SERVICE BULLETIN

FLT SERVICE INFORMATION

Front Brake Calipers

M-842

Figure 2. Rear Swing Arm — Exploded View

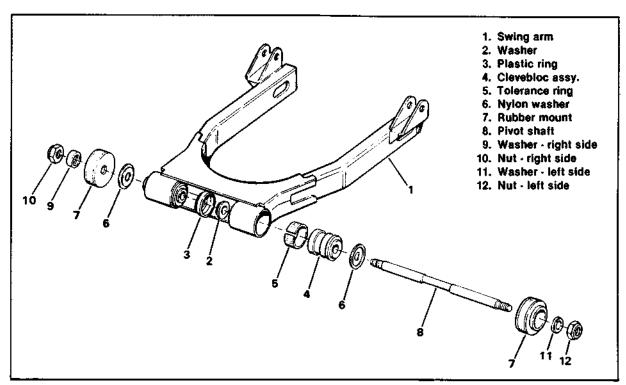
The tightening procedure for the swing arm pivot shaft nuts has been changed with the start of the 1982 models. If the following procedure is used on 1980 and 1981 FLT models, it may enhance the dampening ability of the rubber mount system and improve vehicle handling.

- Remove the chrome caps from both passenger footrest support brackets.
- Loosen the right side nut (10) so it is flush with the end of the shaft (8).
- Tighten the left side nut (12) so the washer (11) bottoms on the shoulder of the shaft.

Tighten the right side nut (10) to 45 ft-lbs torque and replace the chrome caps. See the 1980 to 1982 FLT/FXR SERVICE MANUAL for complete swing arm removal and installation procedure.
